Project: 90009590 - I-405 - Brickyard to SR527  
 Bothell, Washington 98011

## BY-CRE-03798\_009727\_RFI\_00627\_16.03.02\_BRT Below Grade Waterproofing Revisions Missed Prior to RFC

Washington State Department of Transportation  I-405, Brickyard to SR 527 Improvement Project Contract No. 009727	Doc Type: RFI
		REV#: 0
		SPEC SECTION:
		DATE: 10/22/2025
		CRE #: BY-CRE-03798

**I-405 BRICKYARD TO SR 527**  
**AE 0054-17**  
 I-405 BRICKYARD TO SR527 - IMPROVEMENT PROJECT -  
 BT230 BRICKYARD  
 BRICKYARD STATION - ARCHITECTURAL  
 ELEVATOR SHAFT SECTIONS  
 EAST

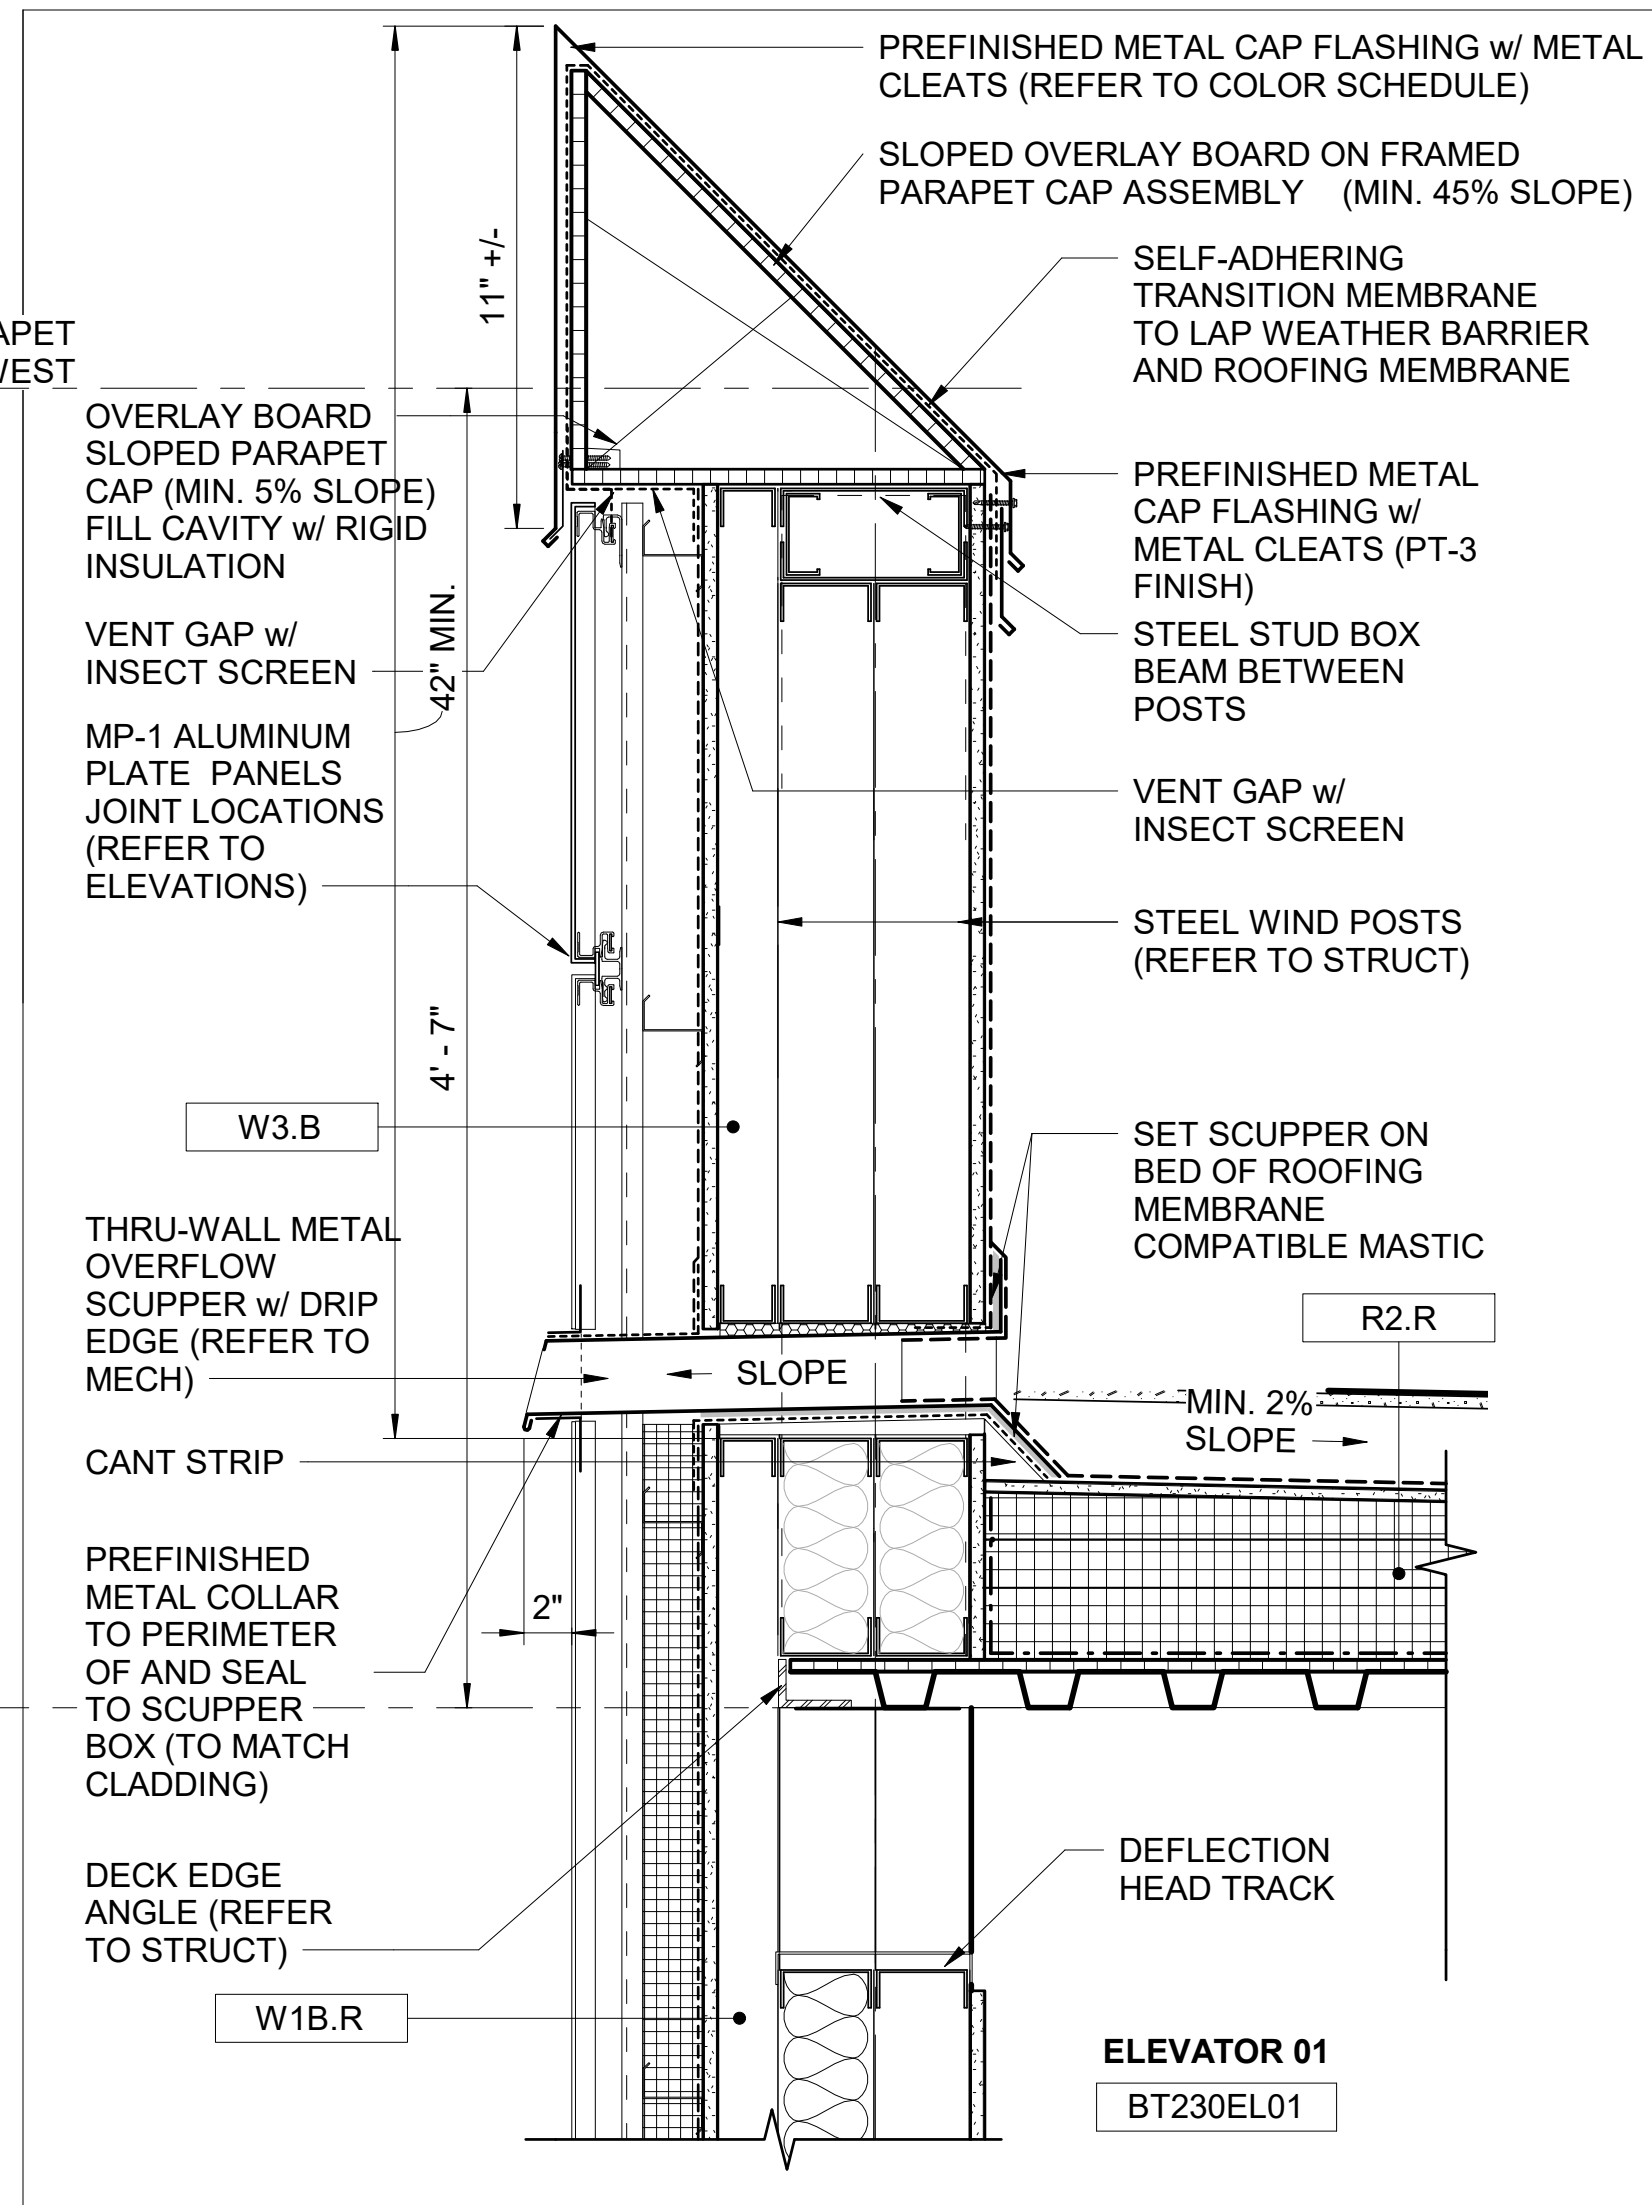
Q. AECOM please confirm all below grade waterproofing that has been marked on the attached drawings should have been removed prior to RFC.

**AECOM response:** Yes, waterproofing should be removed in marked up areas to be consistent with section AVX150 and AEX series where the waterproofing was omitted.

Please note the rigid insulation R-10 still should be extended 2' below grade as indicated.
